RE: ENGINEER'S CERTIFICATION FOR JOHNSON RESIDENCE, LOT 1511, SANDIA
HEIGHTS SOUTH, (D23/D36) (PWD 93-201) SUBMITTED FOR CERTIFICATE OF
OCCUPANCY APPROVAL, ENGINEER'S STAMP DATED 11/27/95.

DRAINAGE INFORMATION SHEET

RE: GRADING AND DRAINAGE PLAN FOR JOHNSON RESIDENCE, LOT 1511, SANDIA HEIGHTS SOUTH, UNIT 15, (D-23/D36), (PWD-93-201), RESUBMITTED FOR BUILDING PERMIT APPROVAL, ENGINEER'S STAMP DATED 10/16/94.

JOHNSON RESIDENCE
 1511 EAGLE RIDGE ROAD NE
 ALBUQUERQUE, NEW MEXICO 87122

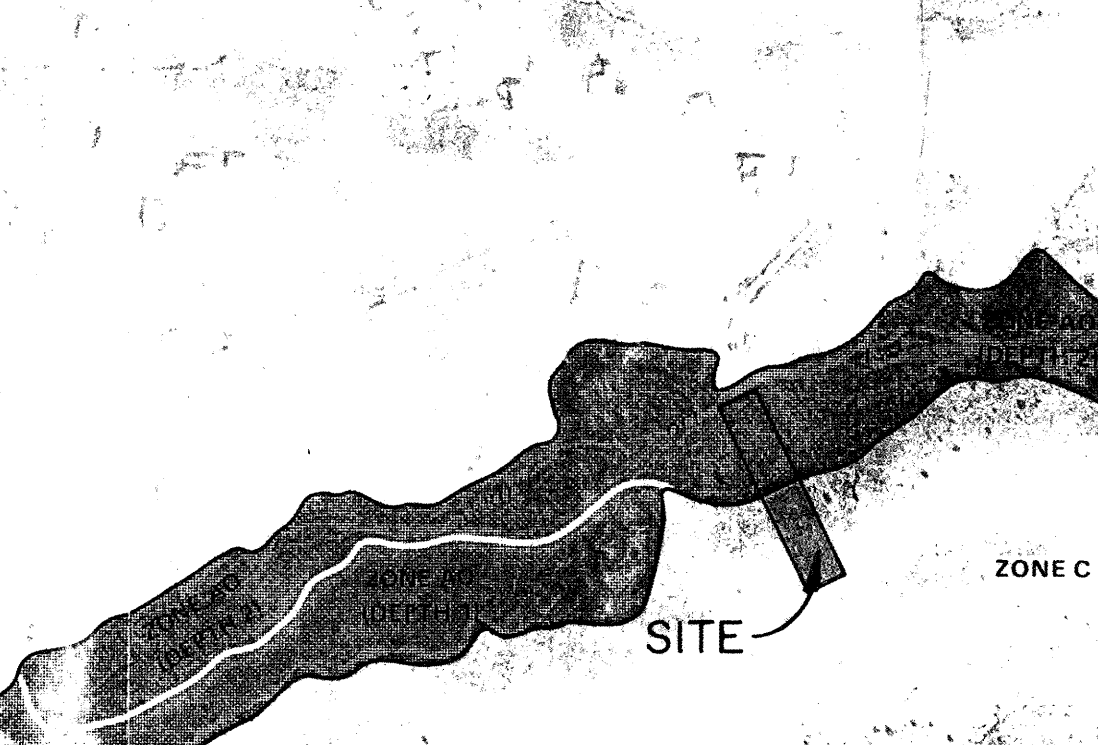
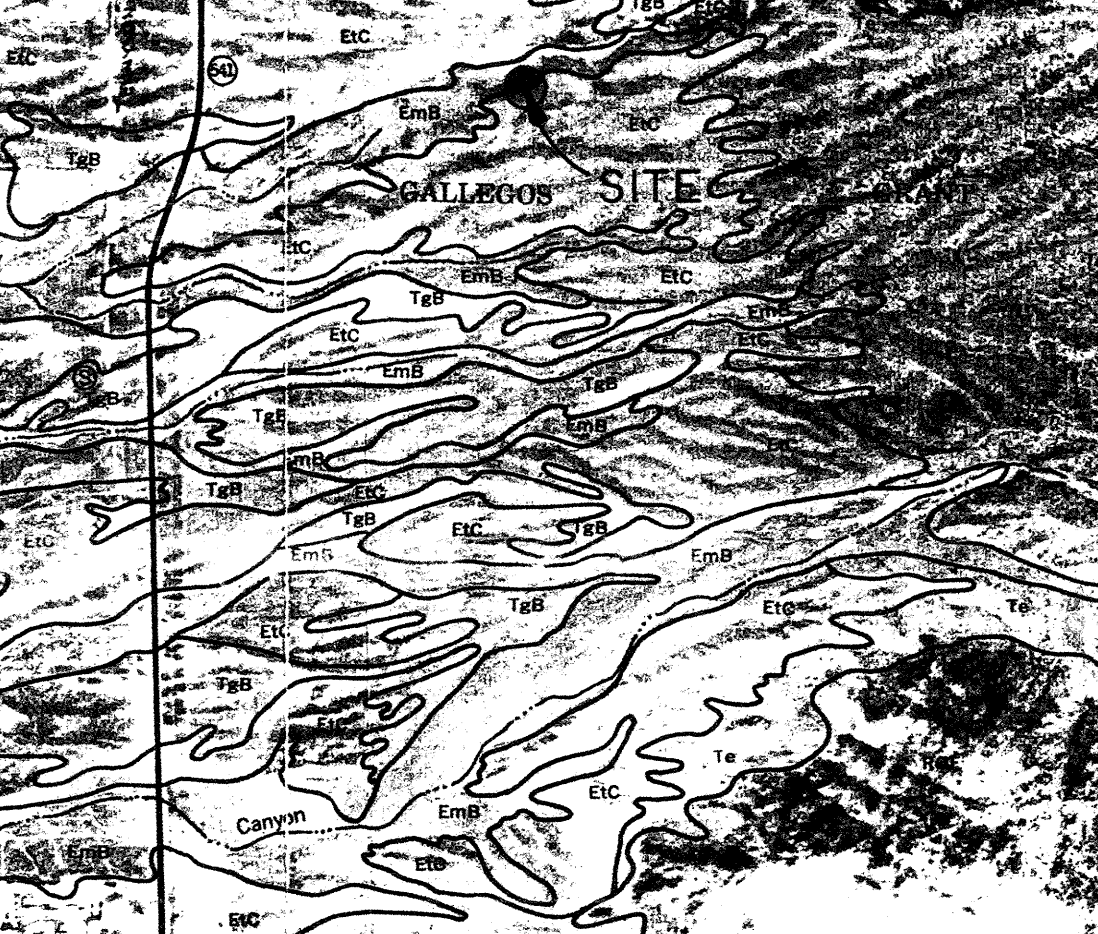
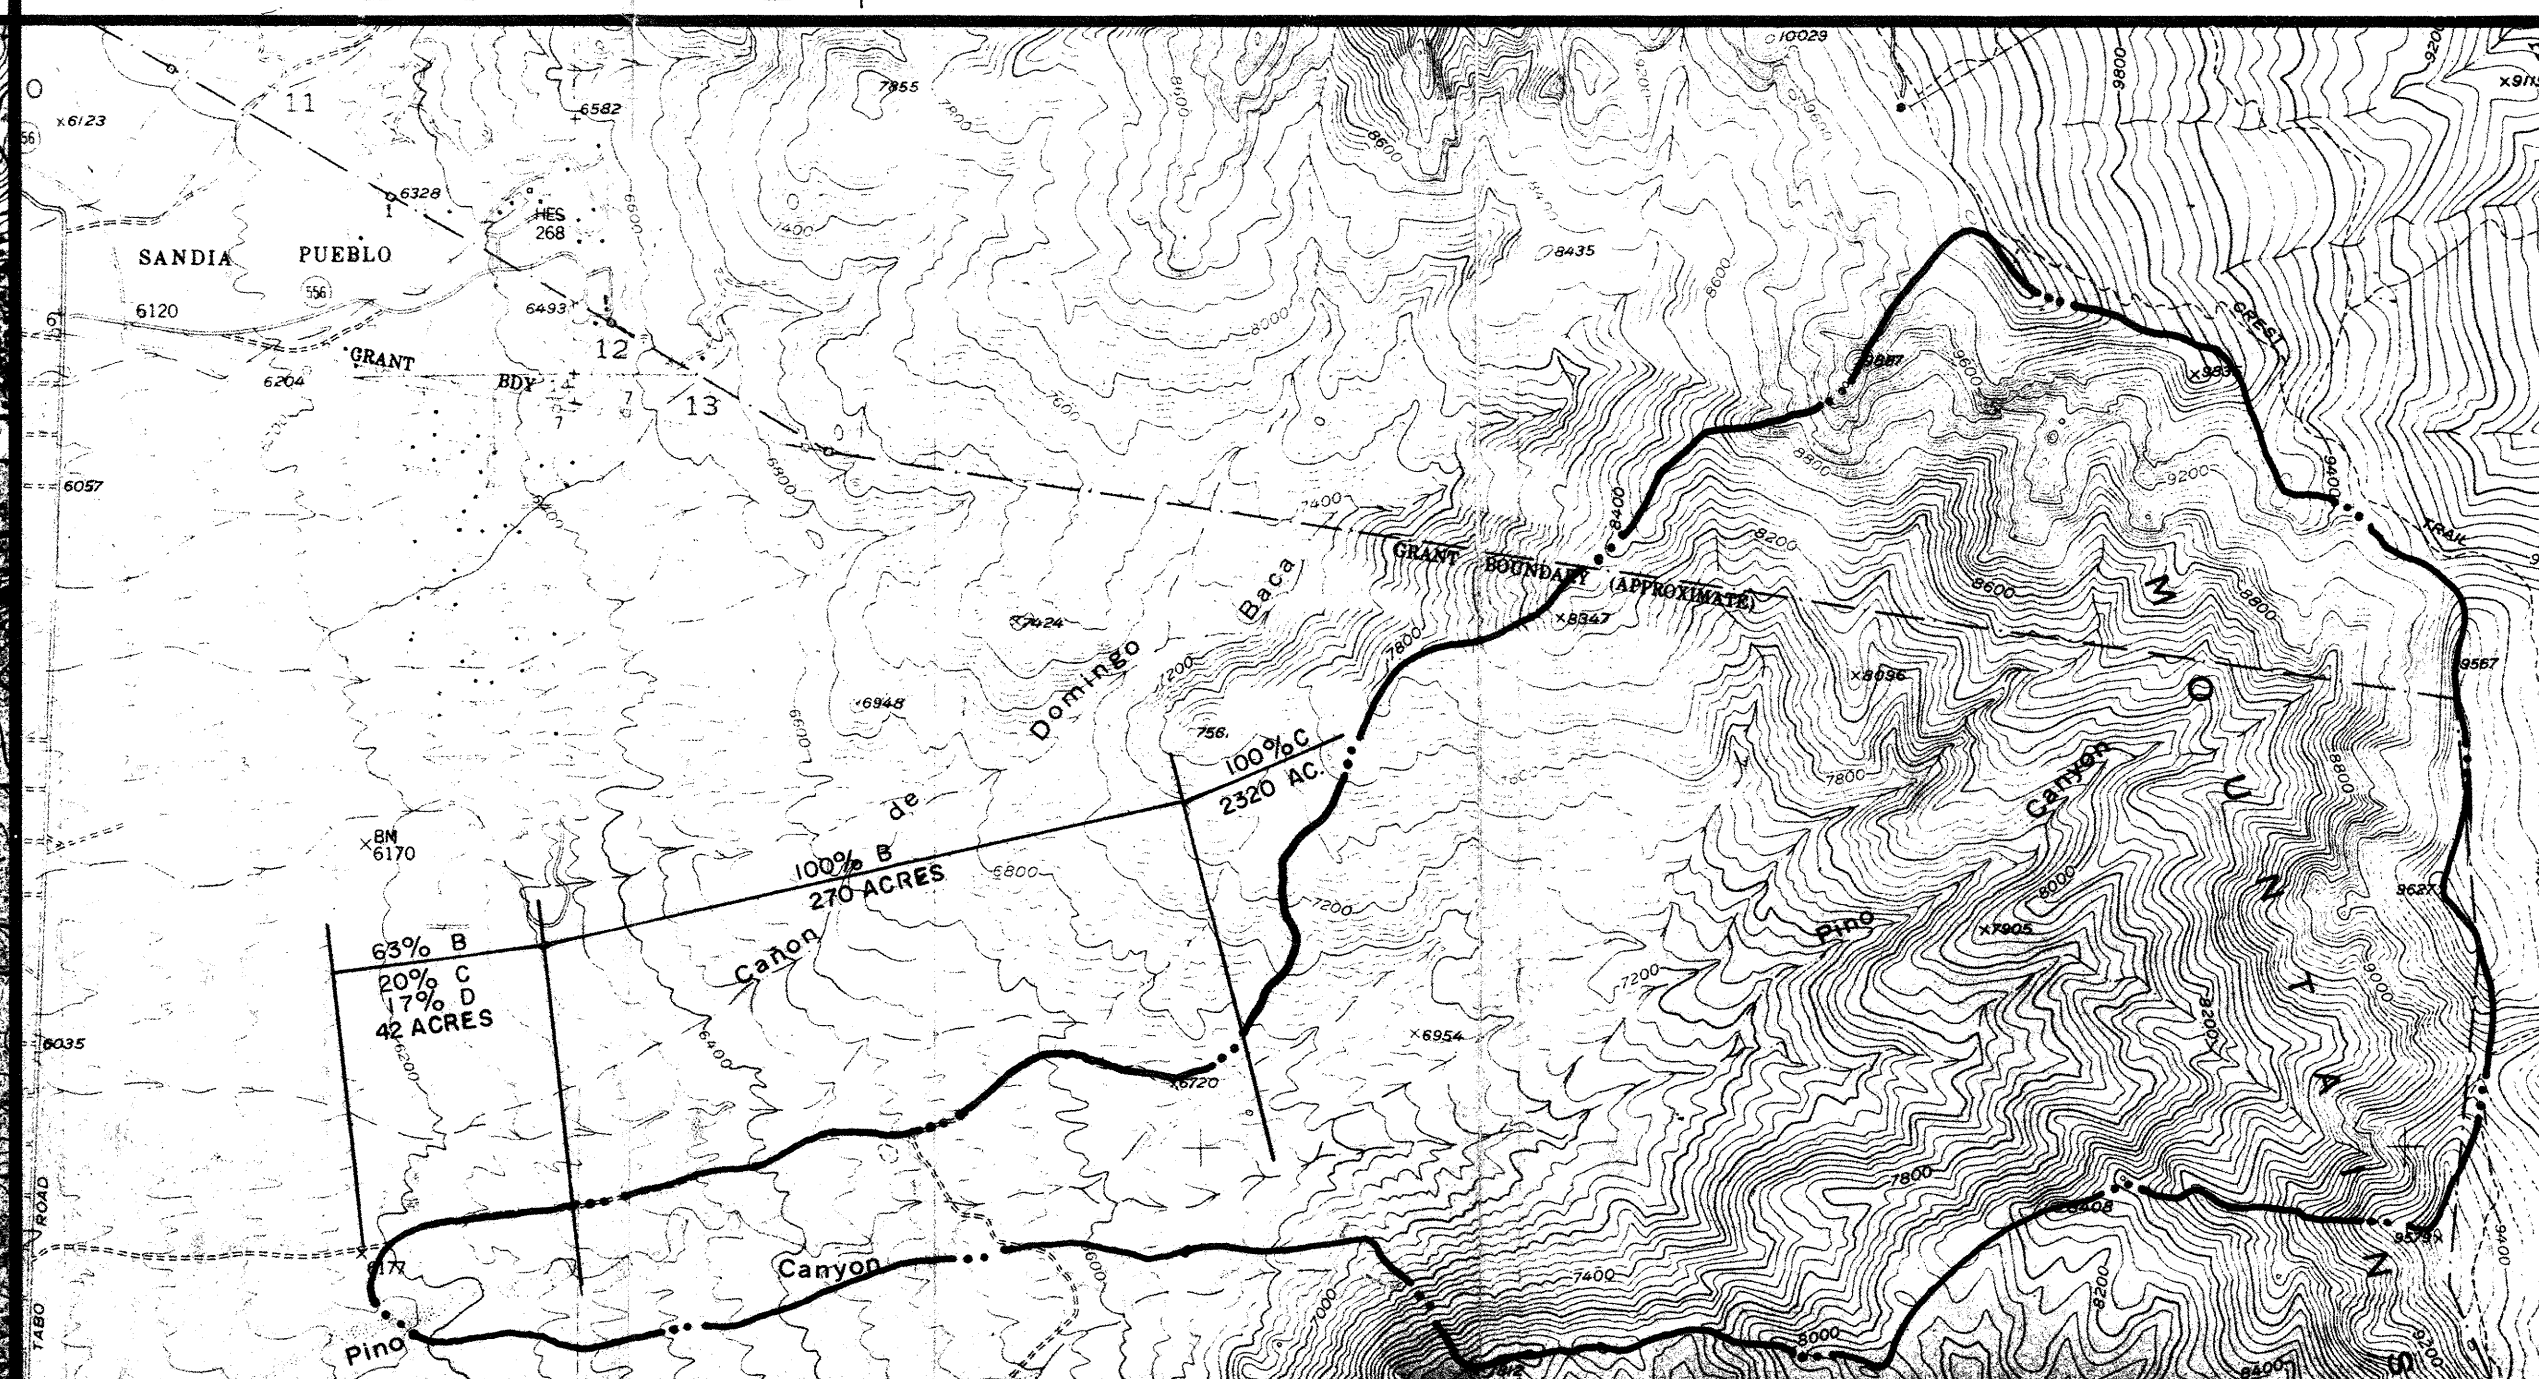
It appears on the plan that the flood plain, as scaled from the Flood Insurance Rate Map, is outside the platted drainage easement. In the future, please reference any existing easements, and if they are granted by plat, include a copy of the plat.

Also, with all future submittals, show complete calculations and the entire site. All easements, setbacks and flood plain boundaries must also be shown on the site plan.
